SANTEE COMMUNITY CENTER
CIP 2018-31

ADDENDUM NO. 1

This Addendum No. 1 (132 pages in total) forms an essential part of the contract documents by revising the following:

1 S4.03 WALL SECTION 1/2" = 1'-0"

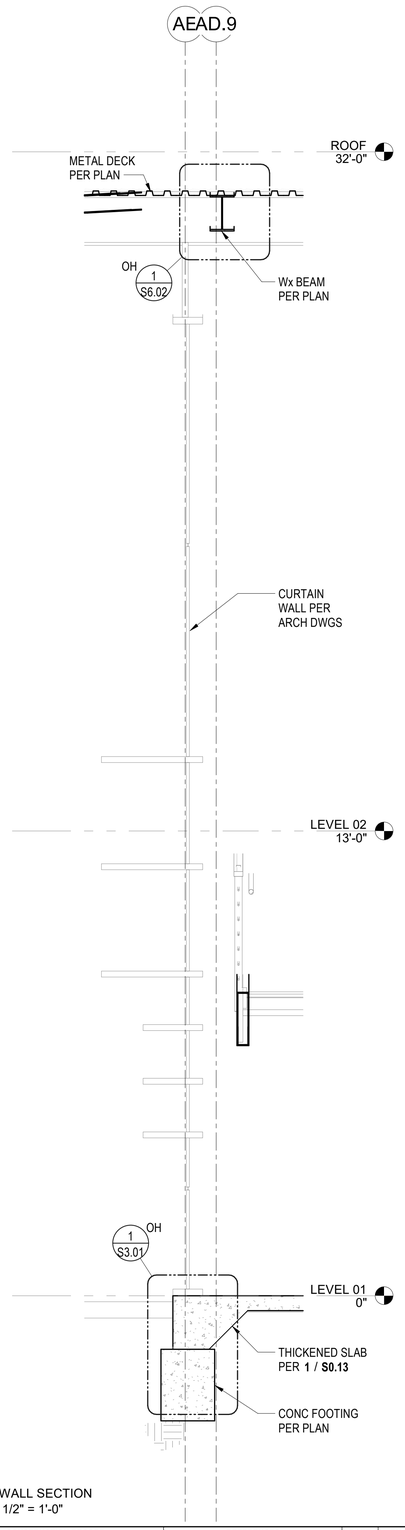
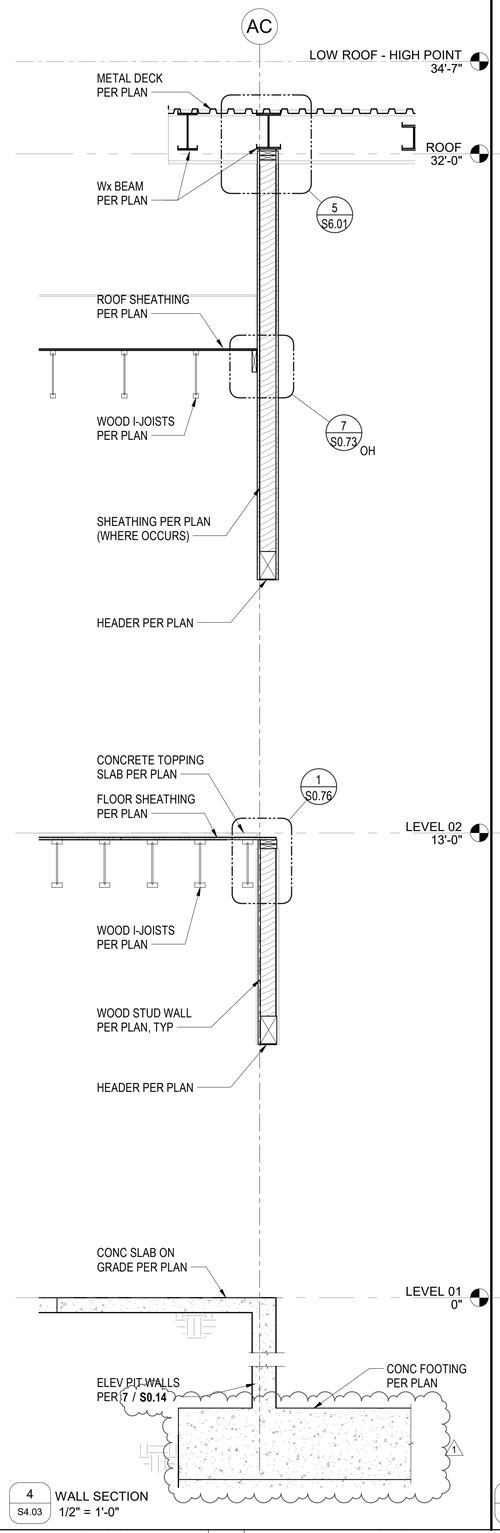
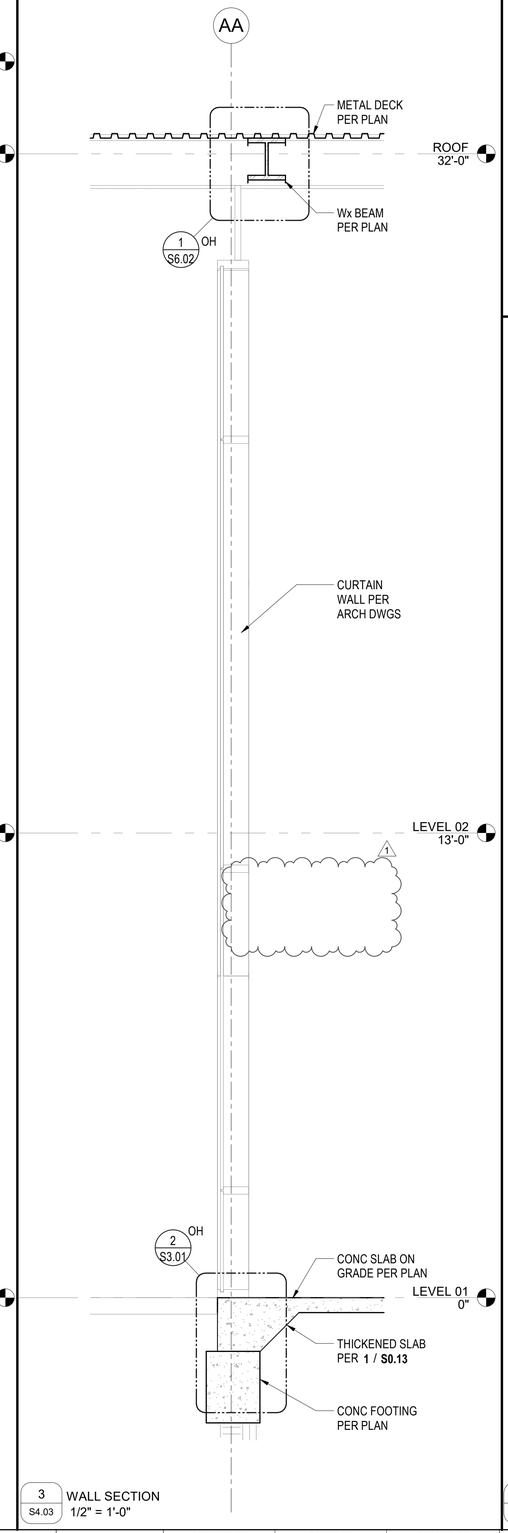
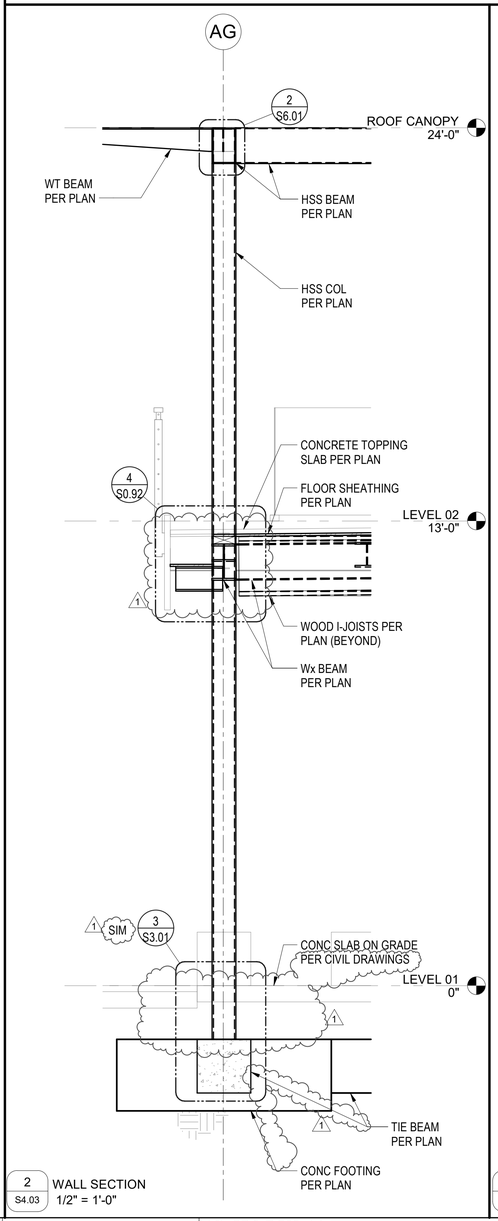
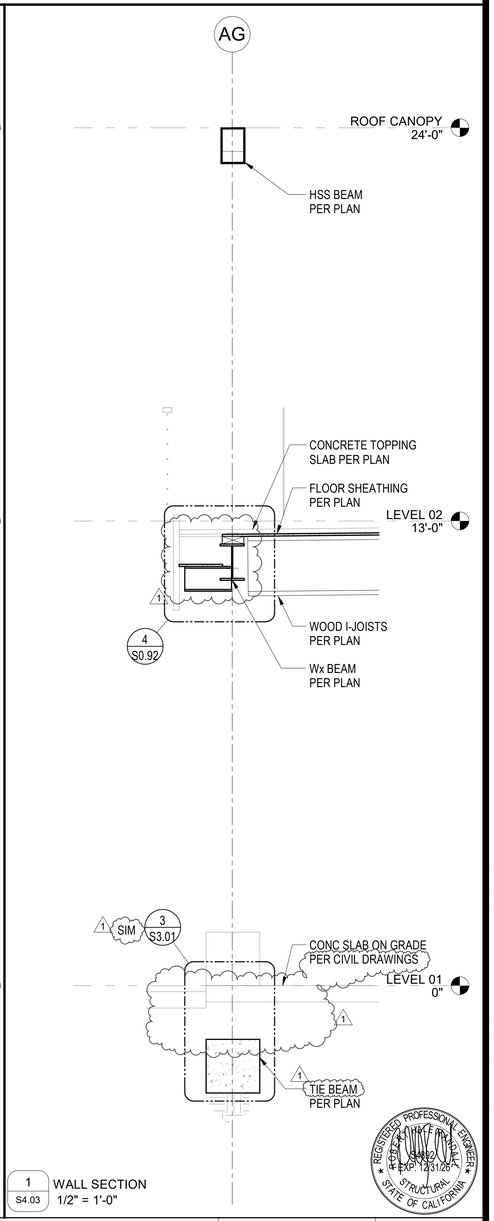
1C-38 Drawing Sheet **S4.03 WALL SECTIONS**
- a. Revised section 1, 2, & 4.

1 S4.04 WALL SECTION
1/2" = 1'-0"

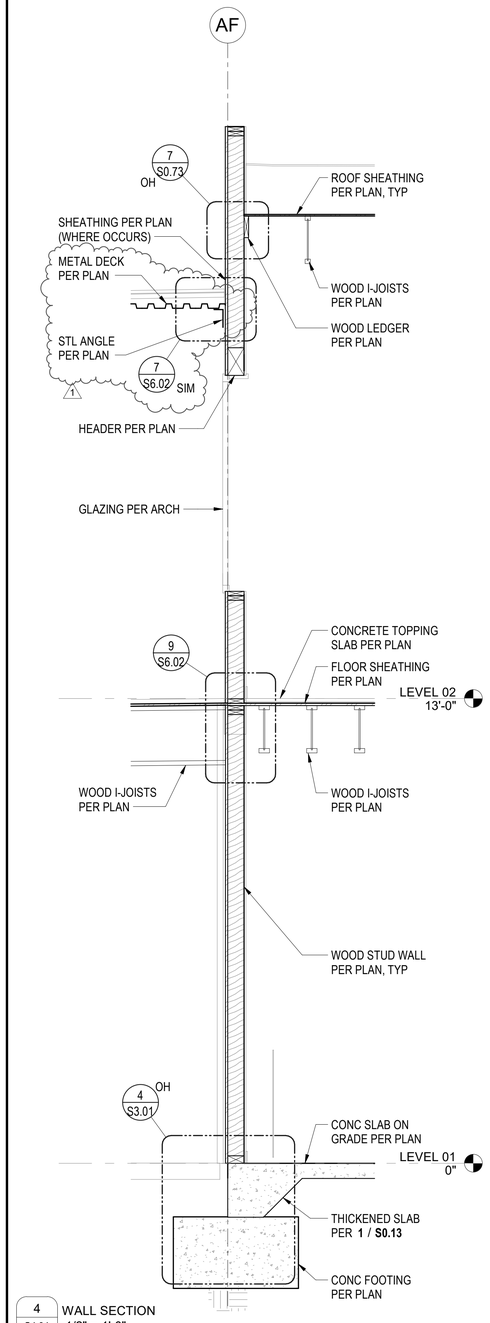
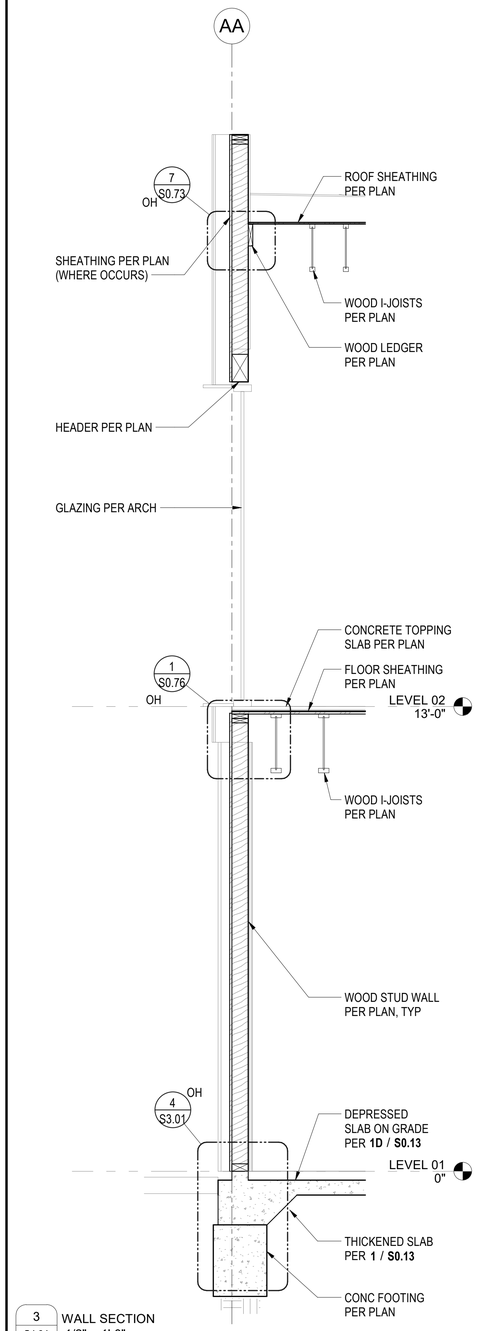
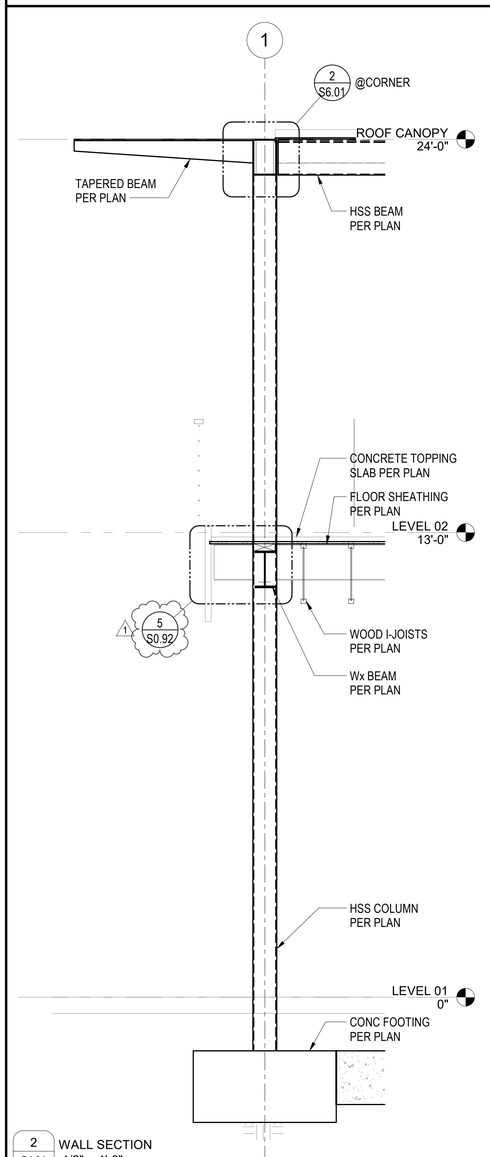
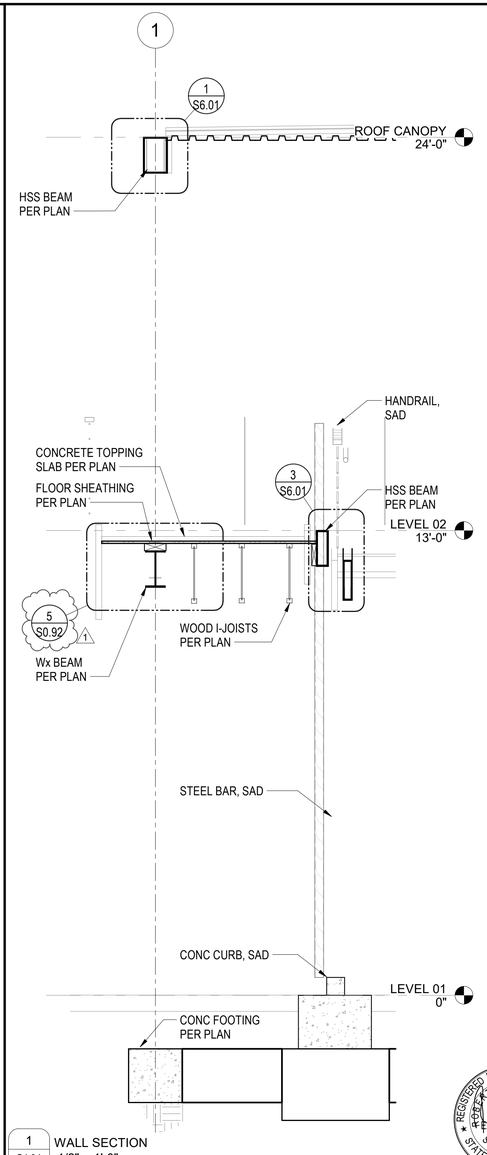
1C-39 Drawing Sheet **S4.04 WALL SECTIONS**
- a. Revised section 1 & 2.
- b. Added deck angle to section 4.

1 / S4.06 WALL SECTION 1/2" = 1'-0"

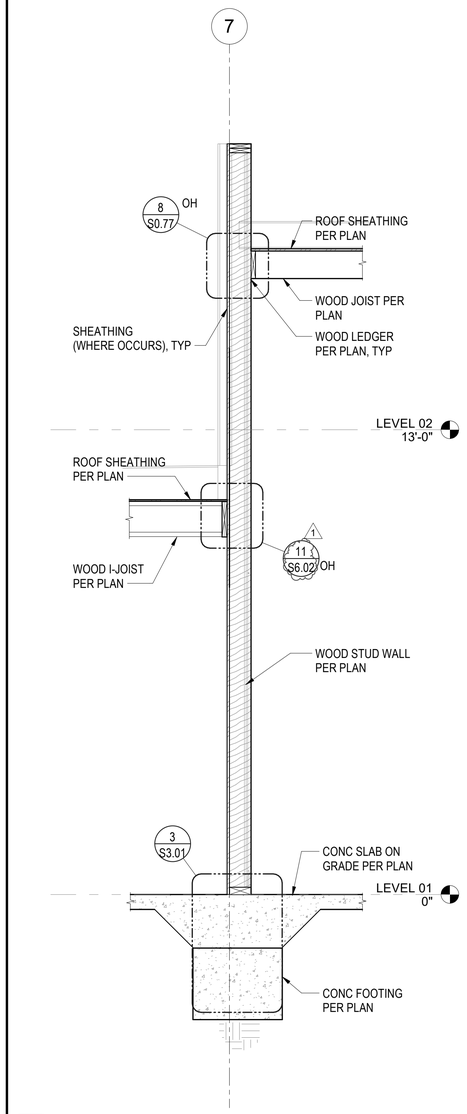
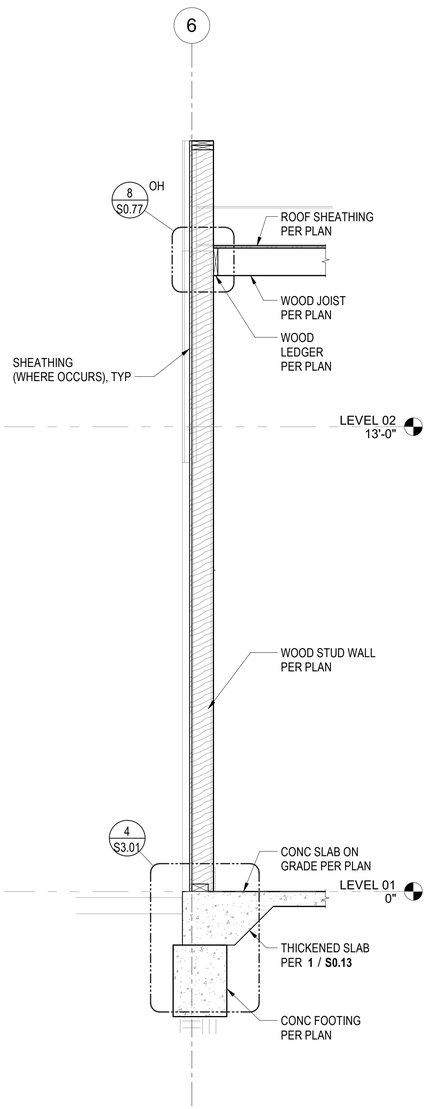
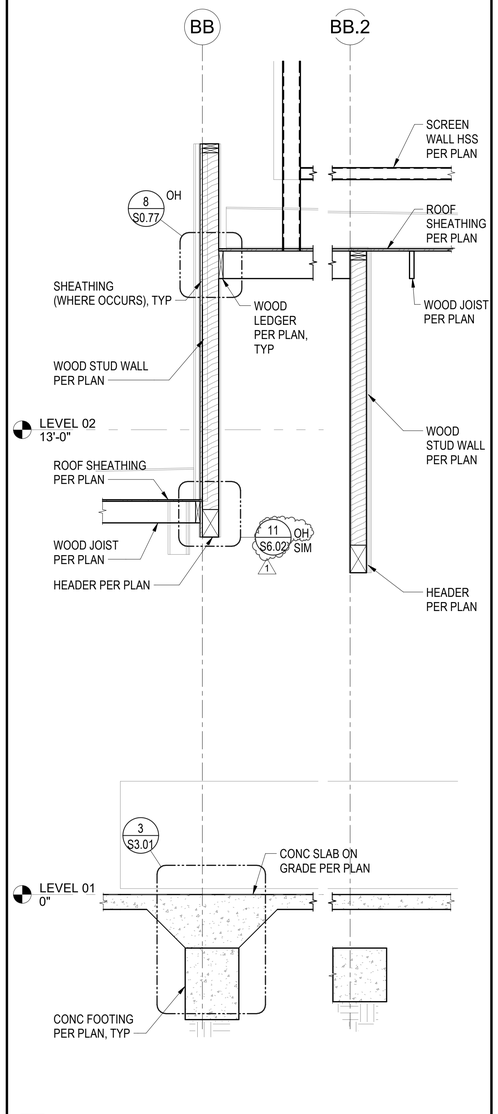
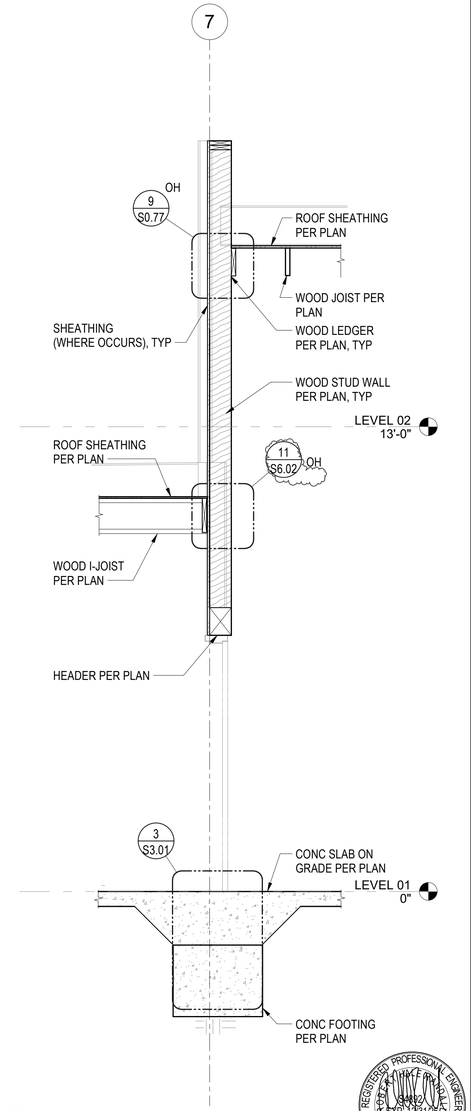
1C-41 Drawing Sheet **S4.06 WALL SECTIONS**
- a. Revised detail references in sections 1, 2, and 4.

3 S4.07 WALL SECTION 1/2" = 1'-0"

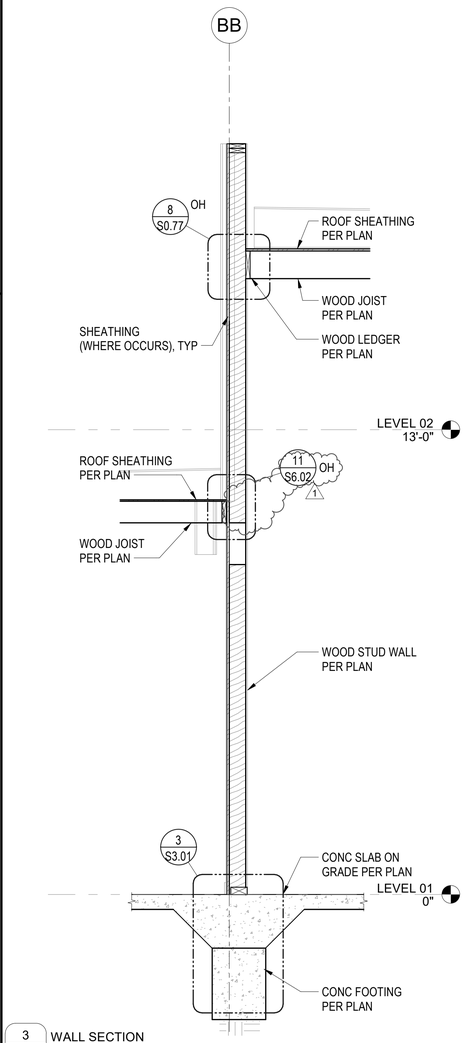
1C-42 Drawing Sheet **S4.07 WALL SECTIONS**
- a. Revised detail reference in section 3.

C S5.01 SHEAR WALL ELEVATION AT GRID LINE 5
3/16" = 1'-0"

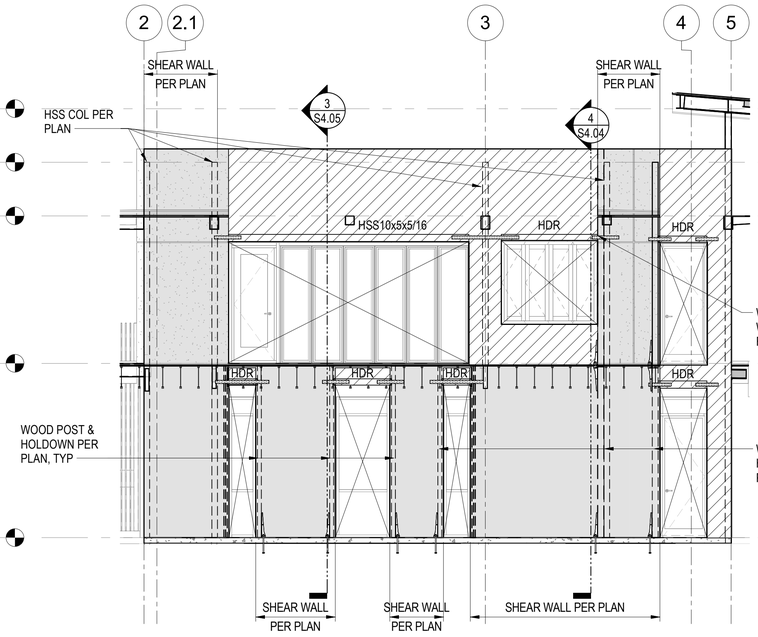
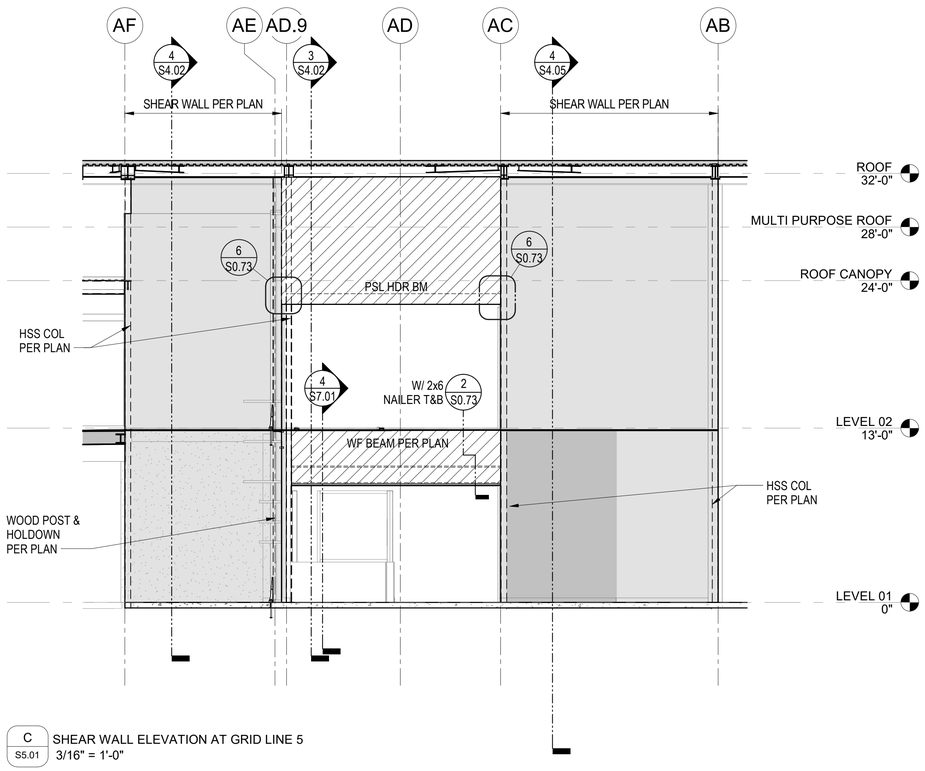
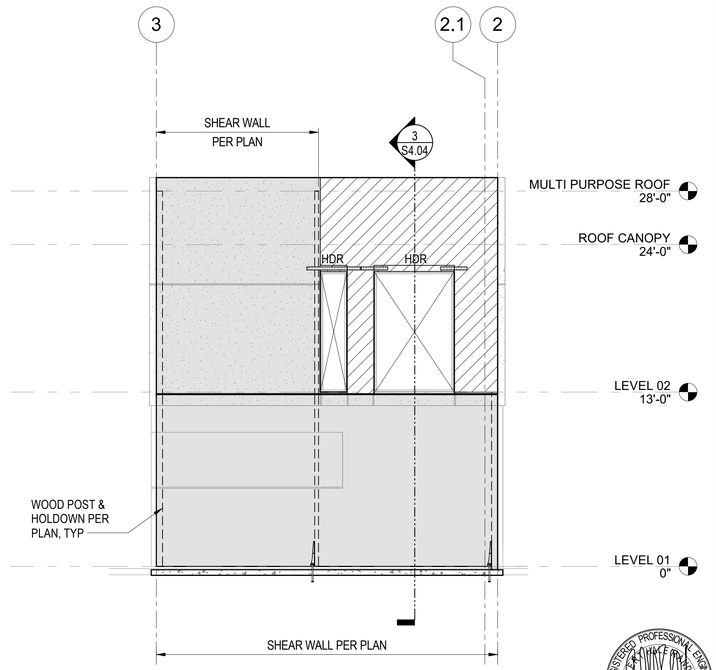
1C-43 Drawing Sheet **S5.01 SHEAR WALL ELEVATIONS**
- a. Added typical shear wall elevation notes 4-6.

B / S5.02 SHEAR WALL ELEVATION AT GRID LINE AC
3/16" = 1'-0"

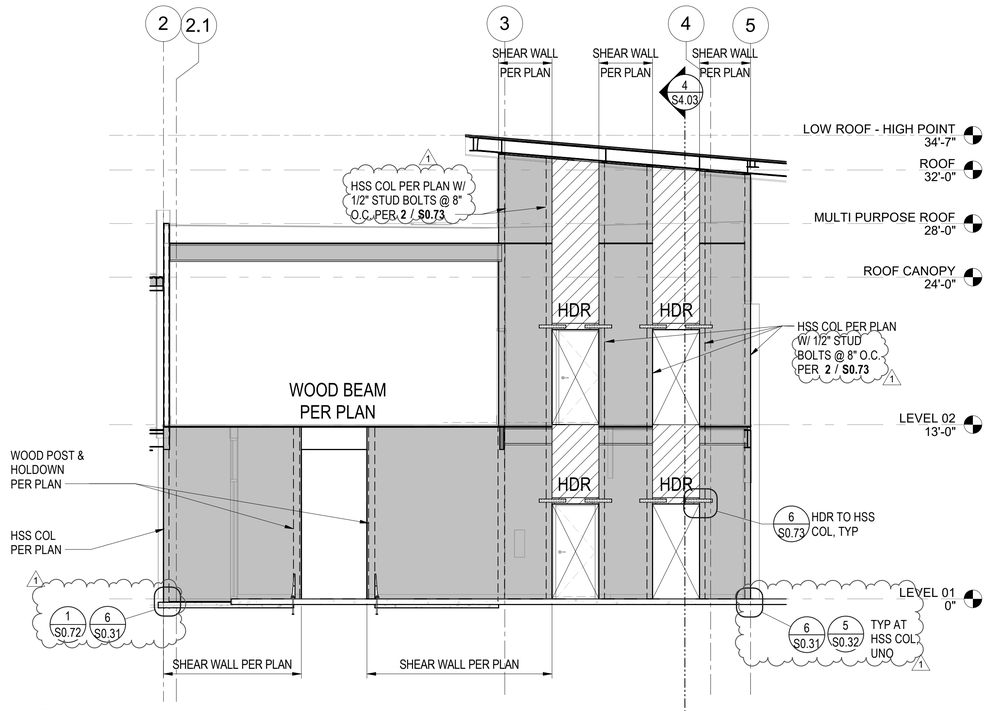
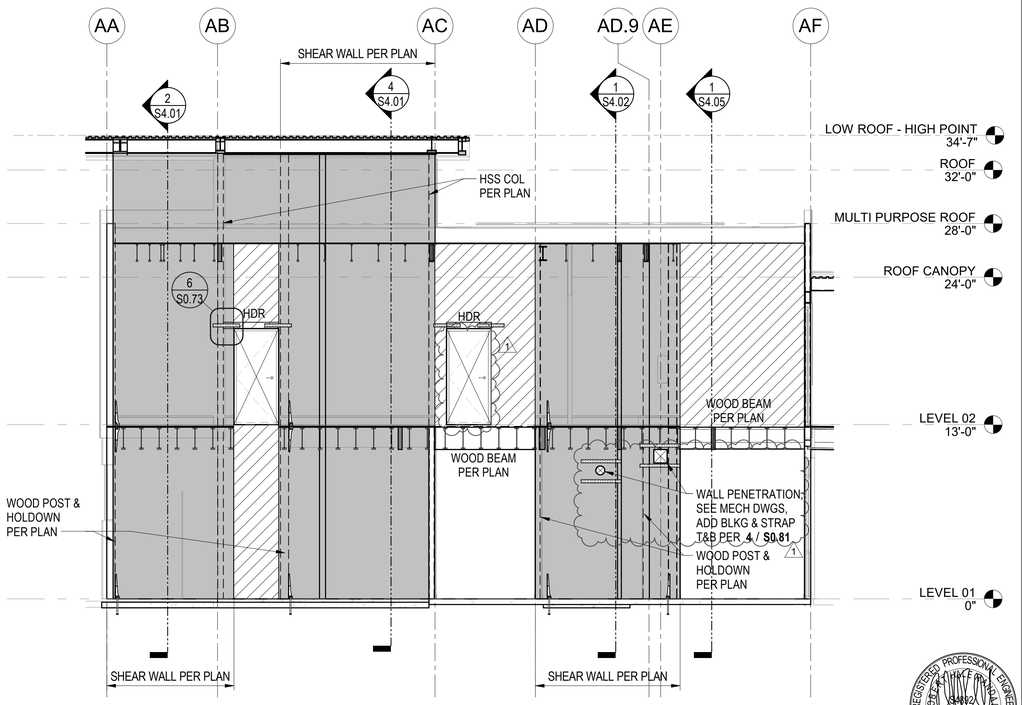
1C-44 Drawing Sheet **S5.02 SHEAR WALL ELEVATIONS**
- a. Added typical shear wall elevation notes 4-6.
- b. Added detail references for clarity.
- c. Added notes for clarity for MEP penetrations.
